**Subject: Transmission of the report of reactive monitoring mission
to the Bagrati Cathedral and Gelati Monastery (Georgia)**

JOINT WORLD HERITAGE CENTRE/ICOMOS REACTIVE MONITORING
MISSION REPORT / RAPPORT DE MISSION DE SUIVI REACTIF
CONJOINTE DU CENTRE DU PATRIMOINE MONDIAL ET DE L'ICOMOS

BAGRATI CATHEDRAL AND GELATI MONASTERY (GEORGIA) /
CATHÉDRALE DE BAGRATI ET MONASTÈRE DE GHÉLATI (GEORGIE)

**REPORT ON THE JOINT
WORLD HERITAGE CENTRE/ICOMOS REACTIVE MONITORING MISSION
TO BAGRATI CATHEDRAL AND GELATI MONASTERY**

Project presented by the State Party to the 2012 mission.

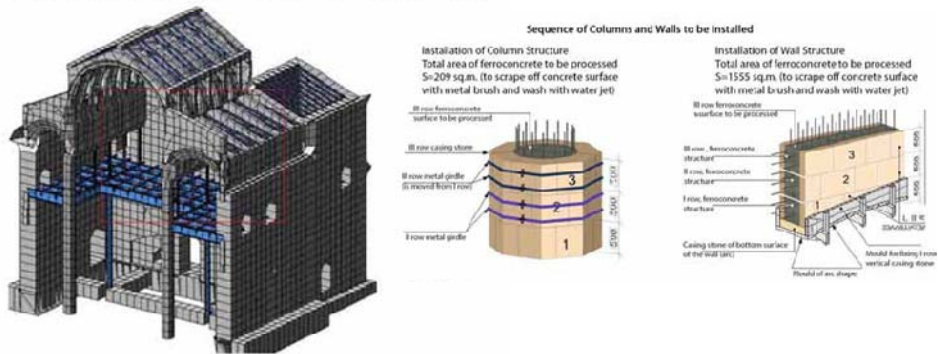
Work on re-building the Cathedral was seen to be progressing non-stop to achieve a full reconstruction of the building, using stone-clad reinforced cement in the central and eastern parts, together with modern interventions in the western part, mostly along the lines of the original monumental project combined with the plans drawn up by the international conservation architect. A cast concrete cupola had already been partially raised up. The State Party confirmed to the mission that the inauguration of the Cathedral is being planned for September 2012.

Although these works were stated to be necessary for the stability of the church in an earthquake zone, in reality these drastic interventions actually allowed the realisation of the first phase of the reconstruction project, in providing the necessary stability to allow for the proposed concrete cupola and the new roof.

A reinforced concrete dome has been installed, theoretically supported by the four central concrete pillars together with concrete arches to supplement the concrete pillars, although the latter are still under construction.

The whole construction has been made out of reinforced concrete, which allows the dome to be supported already by itself, before the realization of the complementary western pair of pillars. All the new (interior and exterior) surfaces are stone-clad. The old surfaces of the church walls that reflect the history of the building have already received the same new stone cladding, based on reinforced concrete.

The mission observed that the current work has not been based on conservation of the existing fabric, some of which was acknowledged as being in an extremely fragile state during the previous mission in 2010, has not respected the archaeological layers, is not reversible.
